TWINBROOK COMMUNITY CENTER RESTROOM RENOVATIONS

FM-5

2024-7746-ALT
THESE PLANS HAVE BEEN
REVIEWED AND APPROVED FOR
CODE COMPLIANCE.
08/13/2024

100% Re-Submission

SHEET TITLE:
LEGENDS, ABBREVIATIONS
AND NOTES

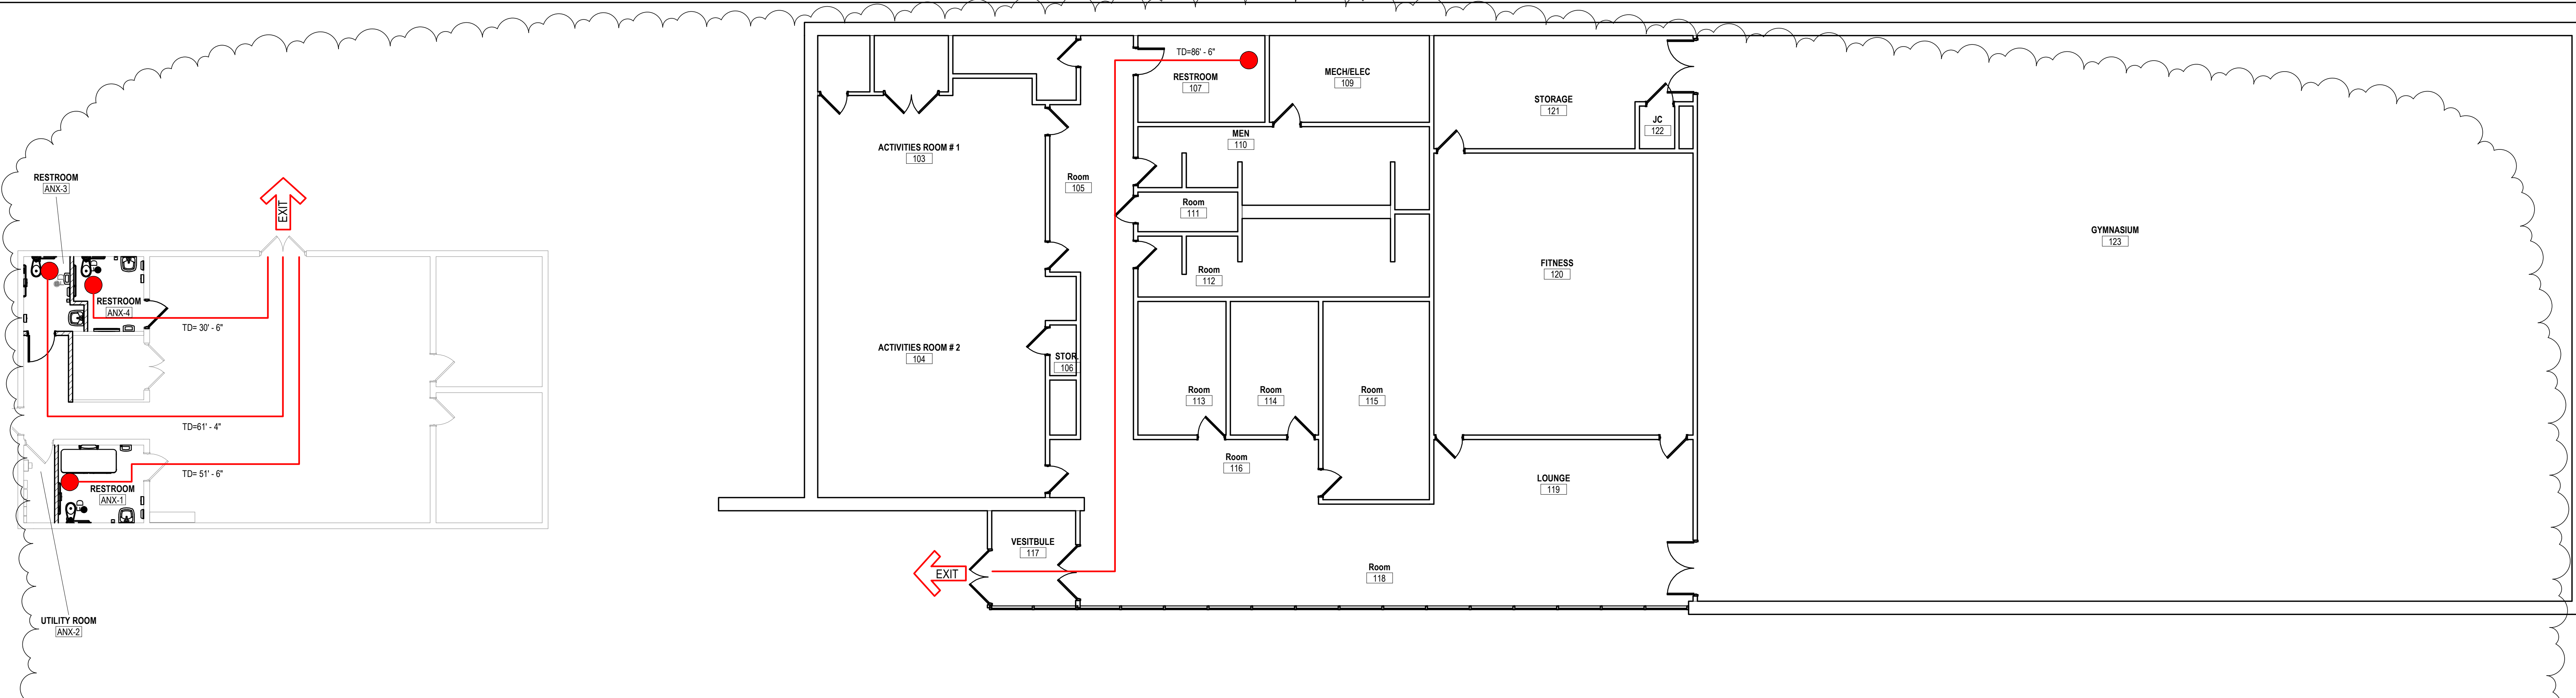
General Notes: These plans have been reviewed for compliance with the Rockville City Fire Code and the 2018 NFPA 101, Life Safety code. Comments are referenced from 2018 NFPA 1, 2016 NFPA 13, NFPA 13R, & 2018 NFPA 101, unless otherwise indicated and shall be corrected prior to final occupancy inspection. Please contact the reviewer whose name appears above with any questions regarding these comments.

These plans were reviewed under Chapter 13, Existing Assembly Occupancies.
These plans were reviewed under Chapter 42, Storage Occupancies.
These plans were reviewed under Chapter 43, building Rehabilitation.

Building is fully sprinklered. Installation or alterations to sprinkler system shall be in accordance with Section 9.7. (Automatic Sprinklers). Submit plans to City of Rockville, Inspection Services Division for review and obtain permit prior to installation/alteration of sprinkler system. Permit required for one (1) or more heads.

Hazardous areas including but not limited to general storage areas, boiler/furnace rooms, maintenance shops, etc. shall have 1-hour separation, or automatic sprinklers and smoke partitions with self or automatic-closing doors. NFPA 101, 39.3.2.1.

Ceiling height shall be not less than 7 feet 6 inches. Projections from ceiling shall be at least 6 ft. 8 in. above the floor. NFPA 101, 7.1.5.1(1).

No door opening in a means of egress shall be less than 32 in. clear width. All projections into the opening (including door hardware) shall be counted as a reduction in the clear width. NFPA 101, 7.2.1.2.3.2. (1 thru 9).

Doors serving a room or area with an occupant load of 50 or more shall swing in the direction of exit travel. NFPA 101, 7.2.1.4.2(1).

During its swing, any door in a means of egress shall leave not less than one half the required width of an aisle, corridor, passageway, landing unobstructed. When fully open, door cannot project more than 7 inches into the required width. NFPA 101, 7.2.1.4.3.1.

Every required exit, exit discharge, and exit access shall be maintained during construction. NFPA 101, 4.5.3.2.

Occupant load calculated at plan review is limited to 38 total occupants (including staff). Final capacity will be determined by the Fire Inspector at time of occupancy inspection.

Exit signs having directional indicators shall comply with Chapter 7. Directional indicator shall be located outside of the exit legend, not less than 3/8 inch from any letter. NFPA 101, 7.10.6.2.

Provide Fire Inspector with flame spread certificates for all interior finishes. Class A or B in the exits and exit access; Class A, B or C for other areas, smoke development not to exceed 450.

Ground-fault circuit-interrupter receptacles shall be installed within six- (6) feet of a sink, 2014 NEC 70, Section 210.8 (B)(1) & (5).

Provide duct smoke detection on supply side for all HVAC systems over 2000 CFM. Detectors shall not activate fire alarm.

Provide a Knox Box key lock box (NFPA 1, 18.2.2.1.) in a location approved by City of Rockville Fire Marshal Office. See attachment or Call 240.314.8256 or 8263 to discuss the requirements with the fire department Knox Box contact person.

Fire extinguishers shall be conspicuously located where they are readily accessible and immediately available in the event of fire. NFPA 10, 6.1.3.1.
